Kenai Peninsula Borough

Meeting Agenda Plat Committee

Monday, July 18, 2022 5:30 PM

KPB File Number 2022-091 7/1/2022

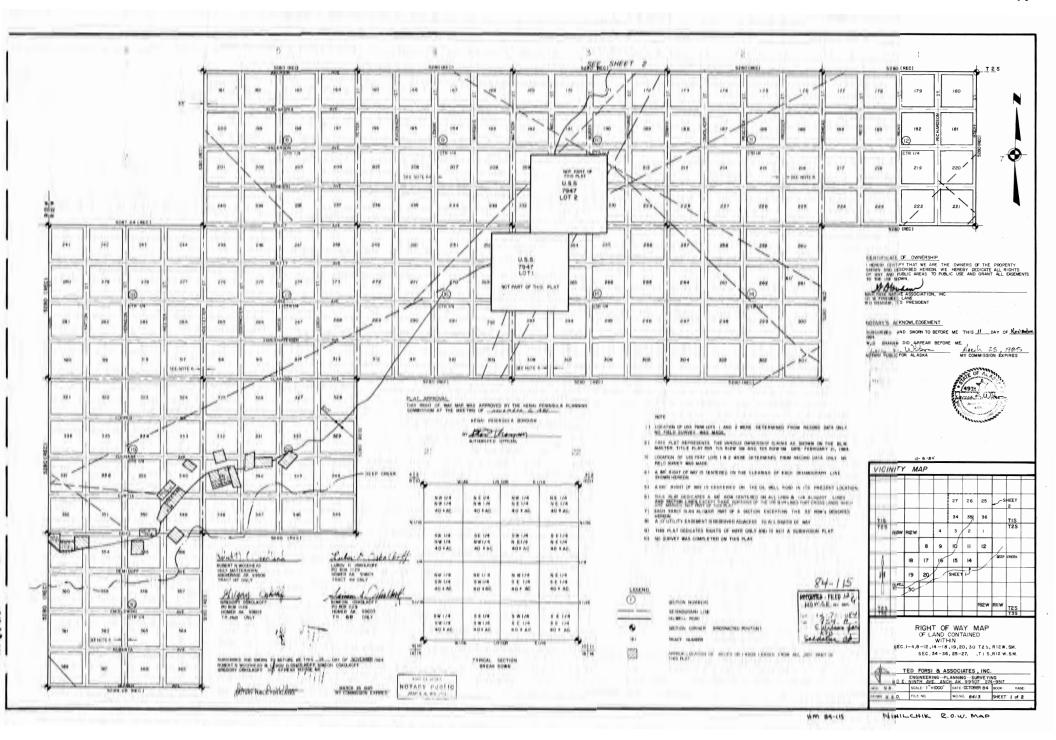
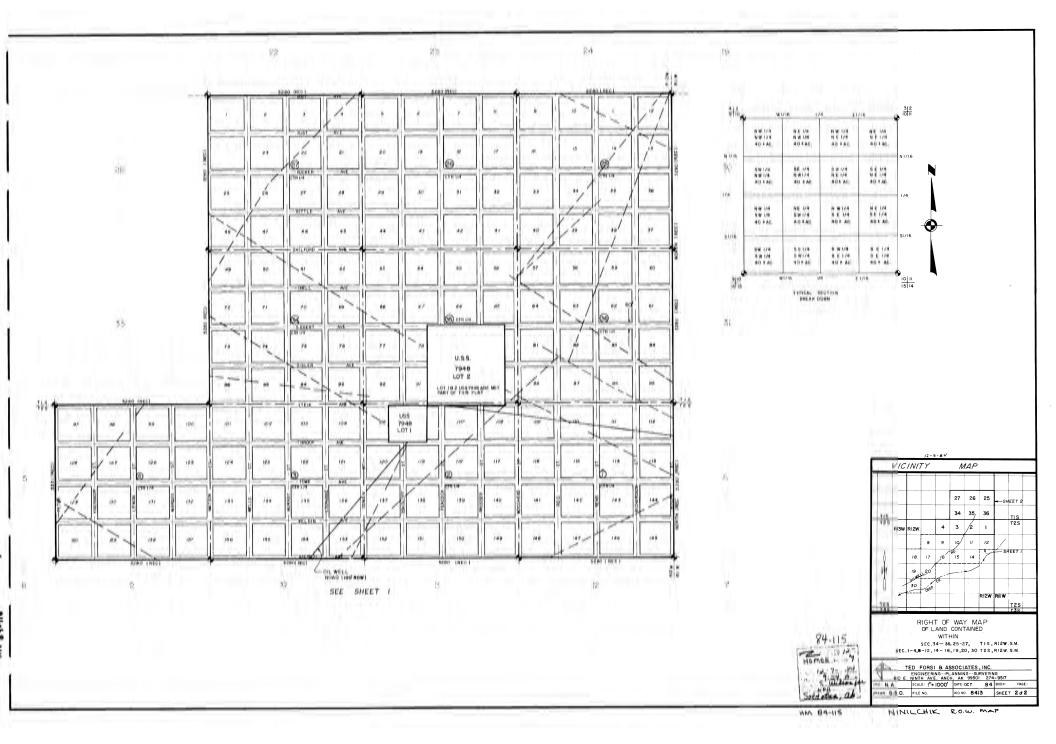
Remove "ROW to be improved" from the final plat. Check REFERENCES for corrections and additional for the final plat.

Staff recommendation: As the property is actually an aliquot description revise to "A subdivision of the NE1/4 NW1/4 of Section 1, Excluding Rights-of-Way, also shown as Tract 110 of Right of Way Map Plat 84-115 Homer Recording District." Also, if approved include in the title block that the plat is finalizing the vacation of a dedicated right-of-way and associated utility easements.

Staff recommendation: Verify the alignment of the section lines for the sections within Range 11 West. KPB GIS data indicates a small shift in section line alignment between the ranges.

Correct plat note 6 by changing "June" to "January" as stated in the Certificate to Plat.

If the vacation is approved and the Assembly consents, add "The Kenai Peninsula Borough Assembly consented to the vacation at the meeting of August 9, 2022."

KPB File Number 2022-088

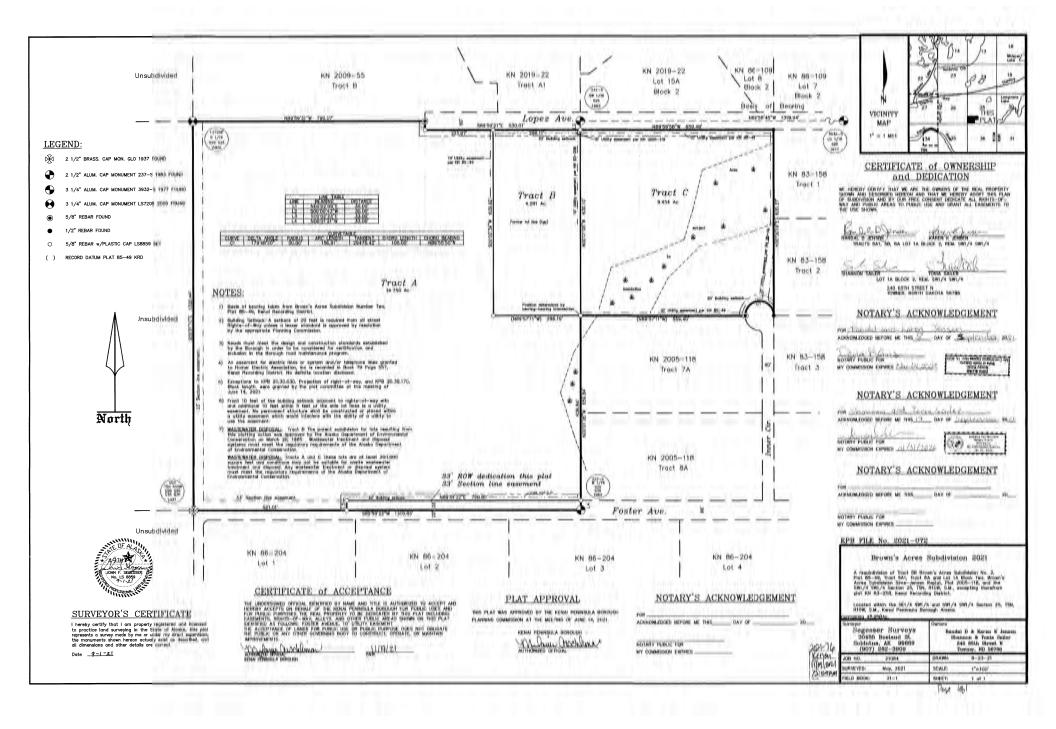
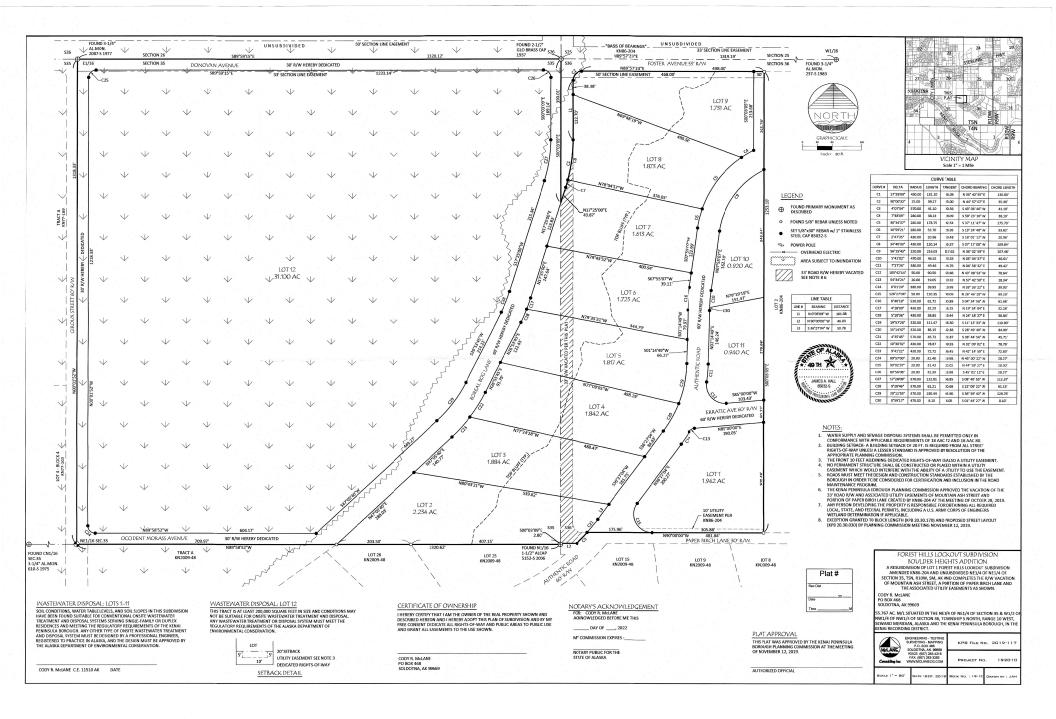
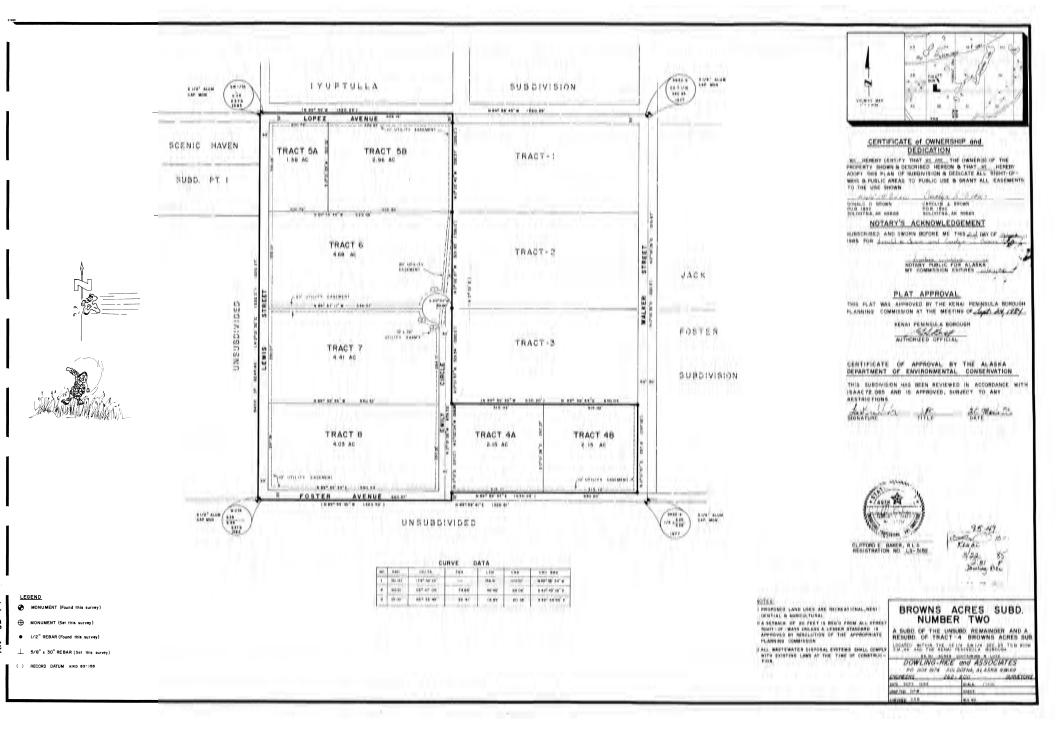
<u>Site Investigation:</u> There are some small low wet areas present in the southwest corner and along the eastern portion of the subdivision. *Staff recommends* the low wet areas be depicted on the final plat and a Corps. of Engineers plat note be added.

- **Staff recommendation:** KPB information indicates that the section line easement adjacent to the western boundary is 50 feet in width. Please verify the width and if the easement is 33 feet in width please provide documentation to the KPB.

Staff recommendation: An approved name will be required, please contact the KPB Addressing Officer
- G. The status of adjacent lands within 100 feet of the proposed subdivision boundary or the land status across from any dedicated rights-of-way that adjoin the propose subdivision boundary, including names of subdivisions, lot lines, block numbers, lot numbers, rights-of-way; or an indication that the adjacent land is not subdivided:
 - **Staff recommendation:** A final plat has been submitted for Forest Hills Lookout Bolder Heights Addition, KPB File 2019-117. Please verify prior to submitting the mylar the status of the plat as the depictions and labels south of Foster Avenue may need updated.

Staff recommendation: The new dedication appears to be within an area with suitable slopes. However, the applicant is requesting exceptions to not dedicate additional rights-of-way due to terrain. Staff will recommend center line profiles for Foster Avenue to show that the right-of-way to connect to the new dedication can be built to borough standards and additional slope easements or dedications of width may be required along Foster Avenue to the newly proposed dedication.

KPB File Number 2022-094

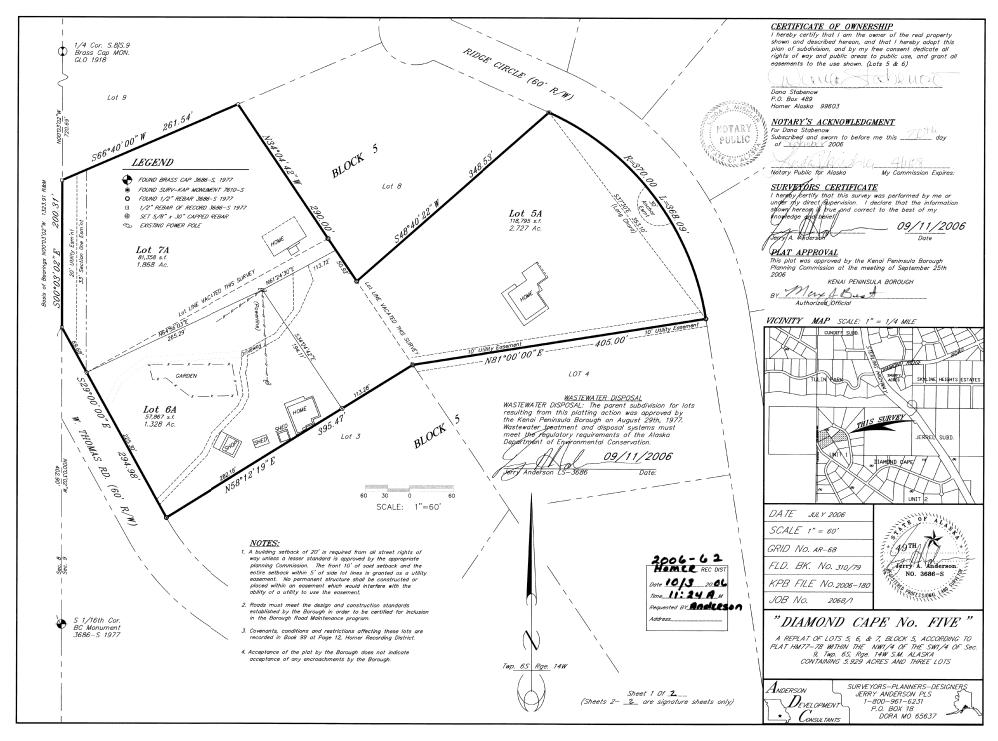
Access for the new lots will not change from the existing access from Ridge Circle. A 33 foot section line easement is located on the western boundary of the subdivision and is depicted and labeled. **Staff recommends** the leader for the Section Line Easement be revised or the label adjusted as it is difficult to see due to the slope depiction.

Staff recommendation: Verify the PO Box for Storyknife Writer's Retreat, KPB Assessing records differ from what is shown on the plat. Add "Block 5" to Lot 5-A information.

Staff recommendation: Correct Lot 2 Block 5 located to the south to Lot 2-A Block 5 and plat HM99-69 and West Thomas Road should be labeled as Walter Thomas Road. Label and depict the section line easements adjacent and providing a connection to Walter Thomas Road.

Plat note 10 may be removed as no new right-of-way dedications are proposed. It appears that plat note 6 and 8 are for the same easement. Please remove one of the notes. Plat note 7 should include a reference to Book 49 Page 319 as this was an additional HEA easement.

Add reference to Plat Note 11 to KPB Code 20.60.200(A), which allows no field survey for this plat.

Staff recommendation: Add to the signature lines to which former lots they are signing on behalf of. Verify the PO Box for the Storyknife Writer's Retreat. Include Erin Hollowell's title for the Storyknife Writer's Retreat. Comply with 20.60.190.
